Attachment B

Decision Table A: Staff Recommended Amendments to the Proposed Draft

Floodplain Resilience Plan

Proposed Amendment A-1: Replacement
for Map 6 in the document

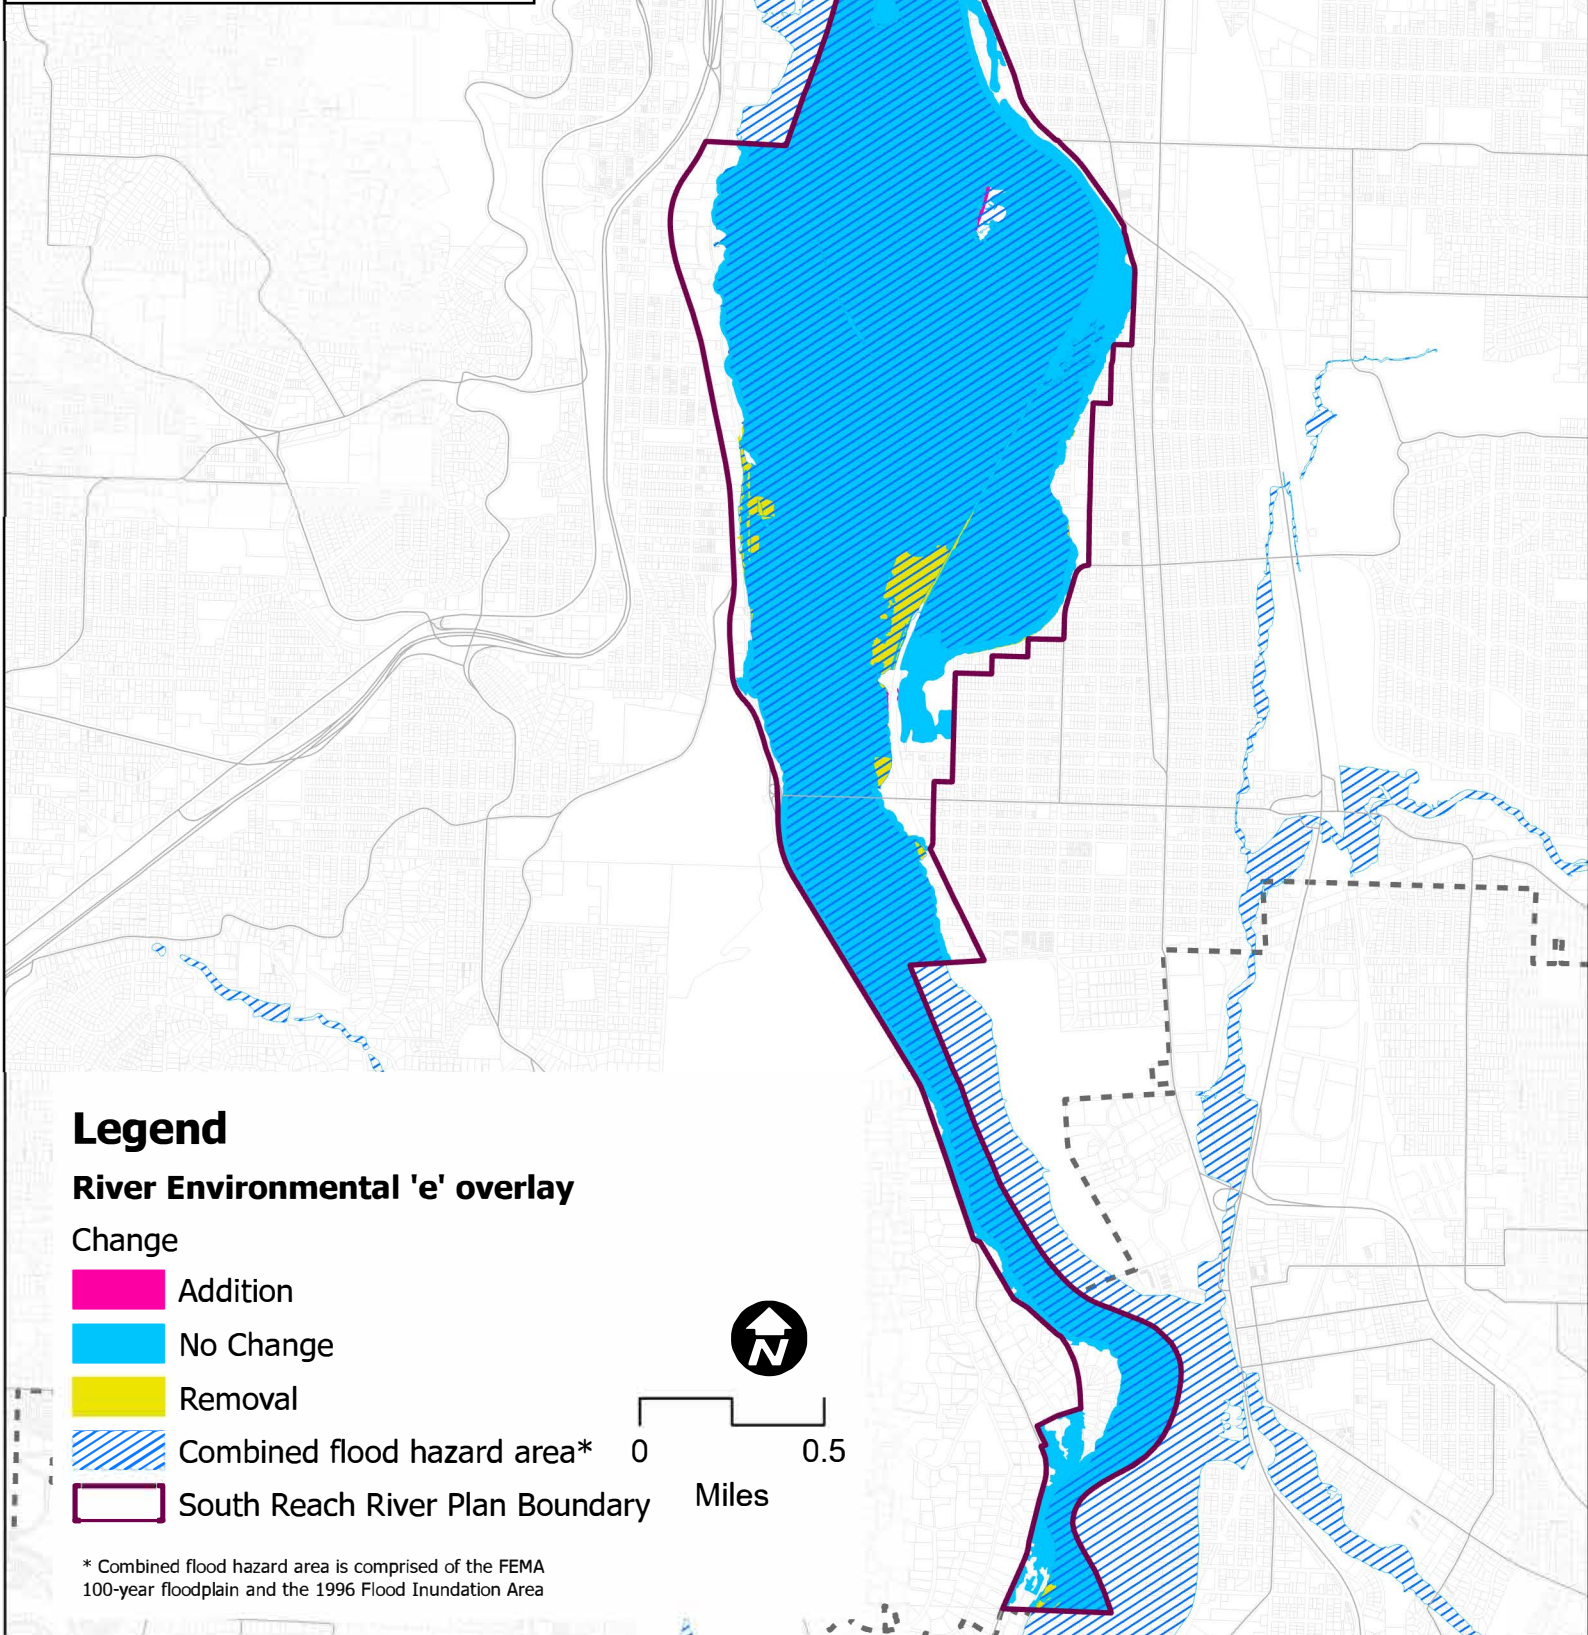
| Ref # | Comment | Commenter(s) | Topic | Comment or Requested Amendment | Staff recommendation | Staff rationale | Discuss? | PSC decision |
|--|---------------------|--------------|---|--|--|--|-------------------------------------|---|
| A-1 | N/A | BPS Staff | Proposed South Reach River Environmental overlay zone | Modify the extent of the proposed River Environmental to apply it to the river setback, land within 100 feet of the top of bank, and all high- and medium-ranked riparian resources. | Replace the Map 6, Proposed changes to the River Environmental Overlay Zone in the Willamette River South Reach, on page 52 of the plan with the replacement Map 6 shown in the collection of maps in Decision Table A - Attachment 1 (see page 12). | The proposed River Environmental overlay in the Proposed Draft inadvertently removed medium-ranked riparian resources that were not in the combined flood hazard area. | <input checked="" type="checkbox"/> | <input type="checkbox"/> Support staff rec. <input type="checkbox"/> Other |

Proposed Amendment A-3: Modify proposed River Environmental overlay zone and riparian buffer area

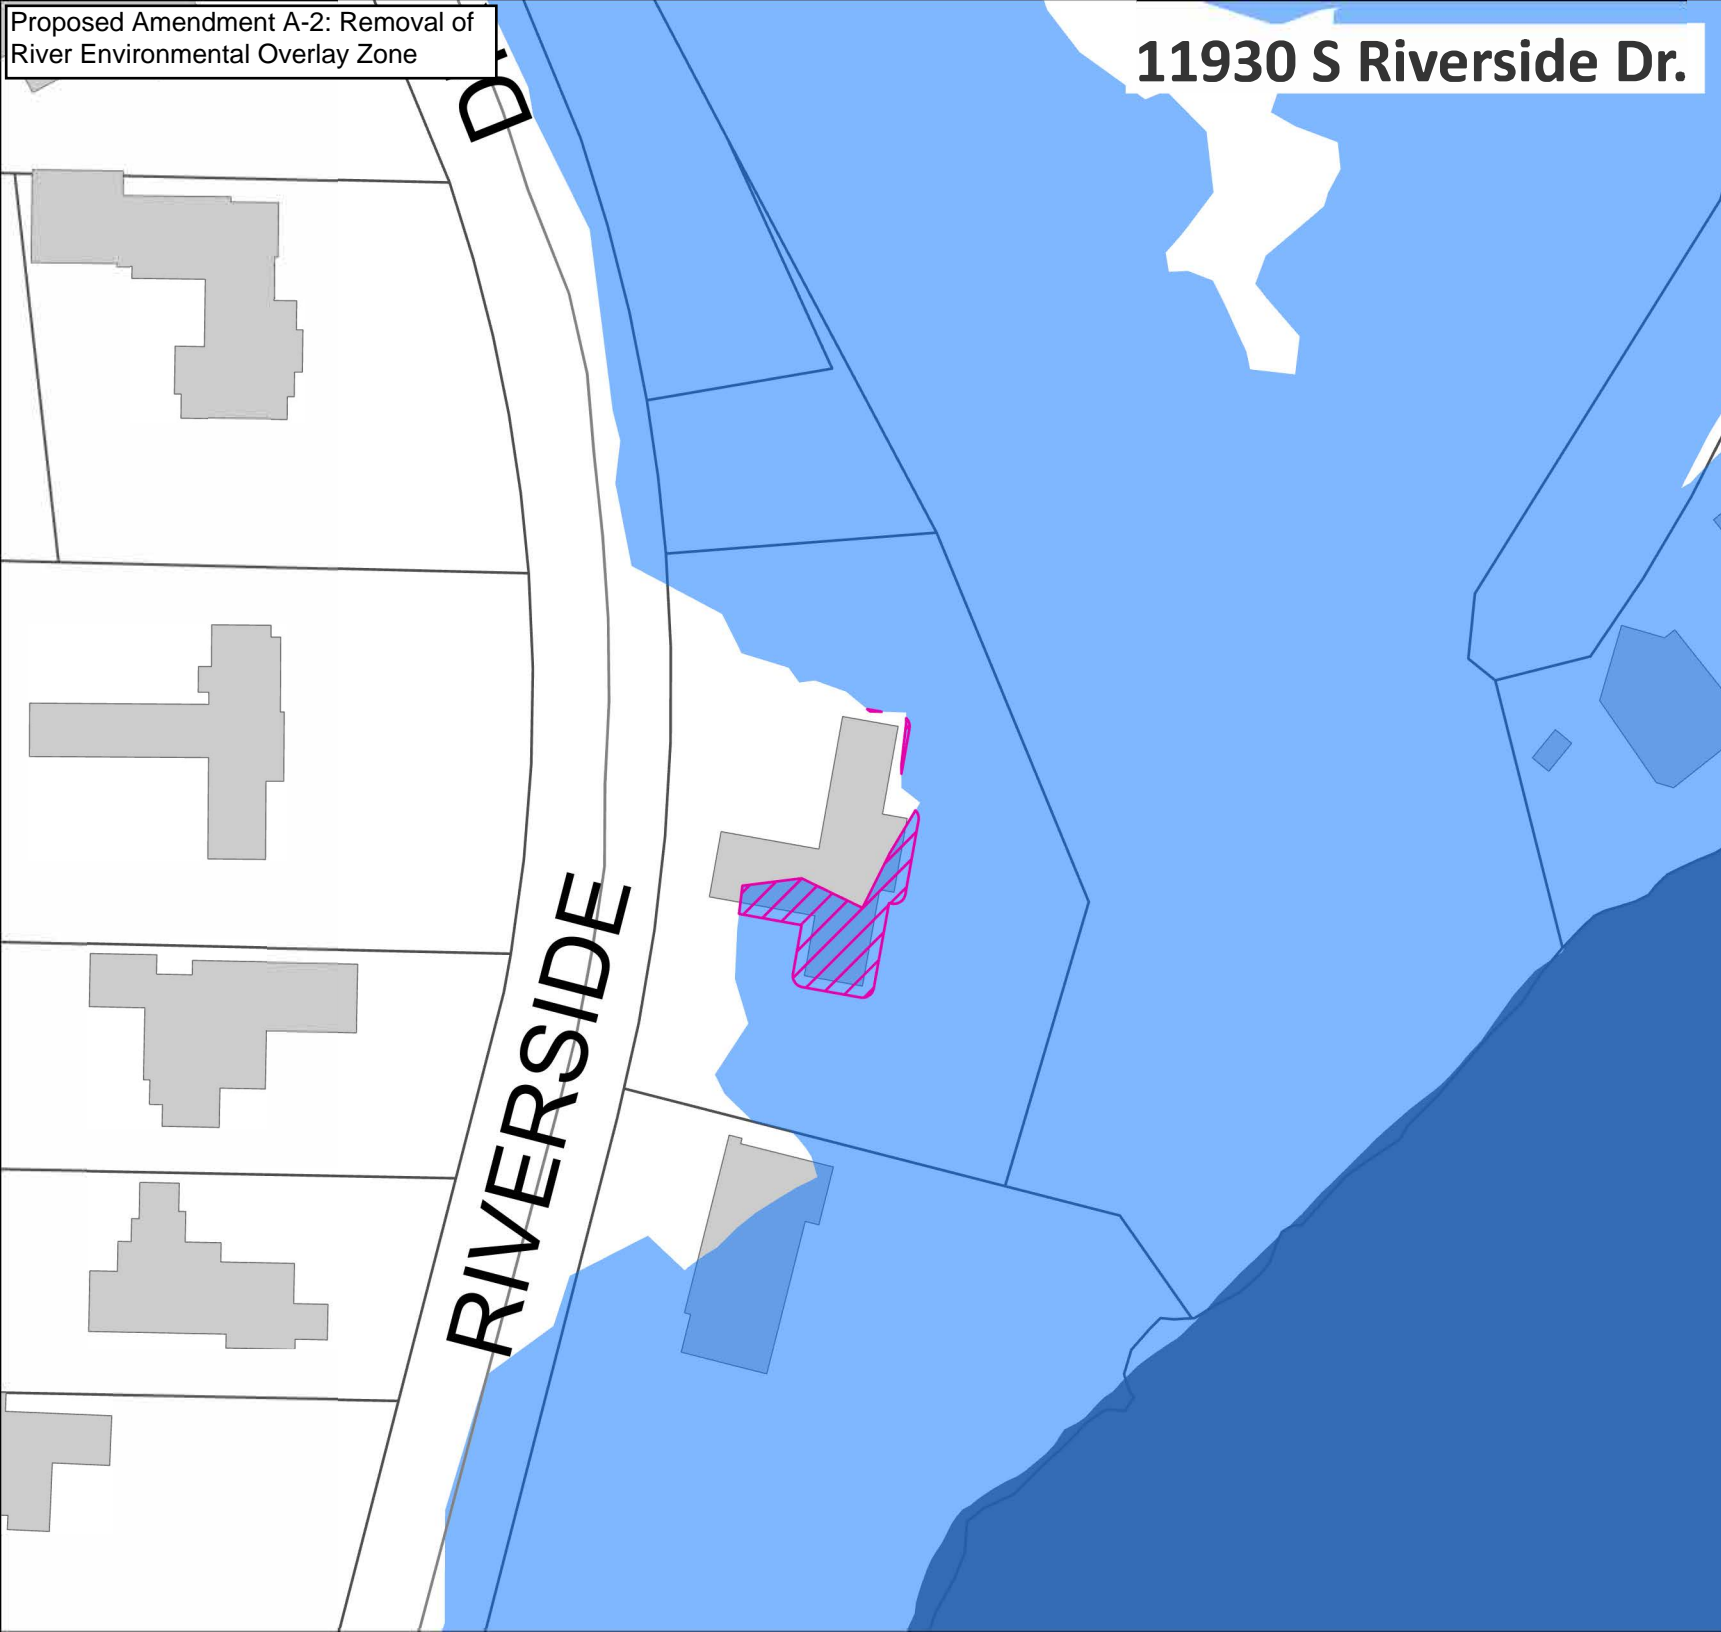
| Ref # | Comment | Commenter(s) | Topic | Comment or Requested Amendment | Staff recommendation | Staff rationale | Discuss? | PSC decision |
|--|---------------------|--------------|---|--|--|--|-------------------------------------|---|
| A-3 | Call with BPS staff | Jim Kurtshaw | Modification of the proposed River Environmental overlay zone and riparian buffer area on Riverfront Place Condominiums site (NW Riverscape St) | Property owner at 1736 NW Riverscape St contacted City staff to request that the River Environmental overlay zone and riparian buffer area proposals be reevaluated because, as a part of the Riverscape development (around 2010), the site was removed from the FEMA 100-year floodplain through a FEMA Letter of Map Amendment based on the site characteristics. | Remove the property from the combined flood hazard area, as the FEMA 100-year floodplain is the only flood map relevant to the site (the Modeled Willamette River 1996 Flood Extent does not extend onto the property). With this modification of the combined flood hazard area, remove the proposed expansion of the River Environmental overlay zone and application of the riparian buffer area on the site. See the modification to the proposed River Environmental and riparian buffer area for this site in the collection of maps in Decision Table A - Attachment 1 (see page 14). | City staff determined that the property had been removed from the FEMA 100-year floodplain through a Letter of Map Amendment and the property should not be considered as a part of the combined flood hazard area. Therefore, the proposed expansion of the River Environmental overlay zone and application of the riparian buffer area on the site is not warranted. | <input type="checkbox"/> | <input type="checkbox"/> Support staff rec. <input type="checkbox"/> Other |

Figure 510-2

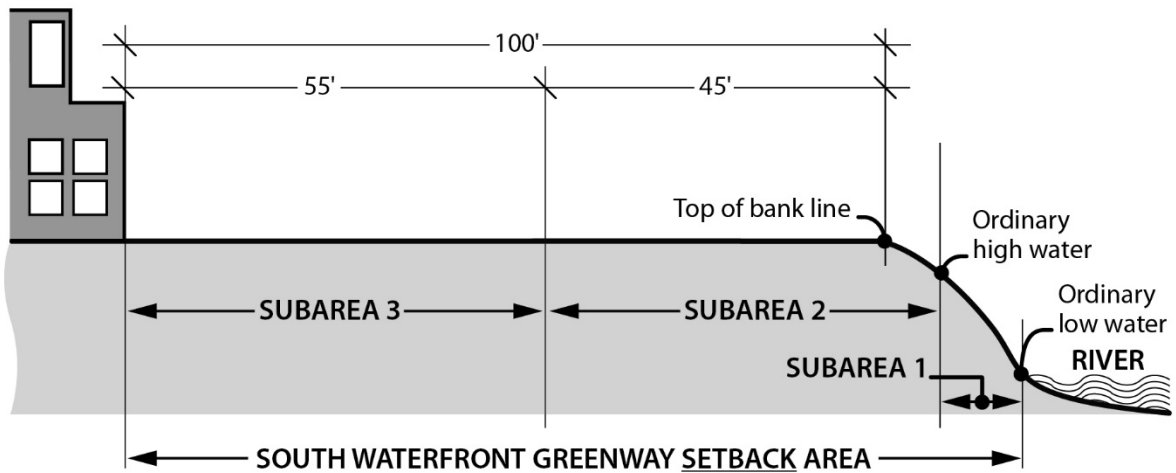
| Ref # | Comment | Commenter(s) | Topic | Comment or Requested Amendment | Staff recommendation | Staff rationale | Discuss? | PSC decision |
|--|---------|--------------|---|---|---|--|--------------------------|---|
| A-11 | 332079 | BDS Staff | Update Figure 510-2 in the South Waterfront Subdistrict (33.510.253.) | The text in Figure 510-2 should be updated throughout to include “South Waterfront Greenway <u>Setback</u> Area” throughout. | <p>Update Figure 510-2 to incorporate “setback” into the figure’s text where the “Greenway Area” is identified.</p> <p>For more detail, see Decision Table A - Attachment 2 (page 24).</p> | Not including “setback” was an oversight. It should be included in Figure 510-2. | <input type="checkbox"/> | <input type="checkbox"/> Support staff rec. <input type="checkbox"/> Other |
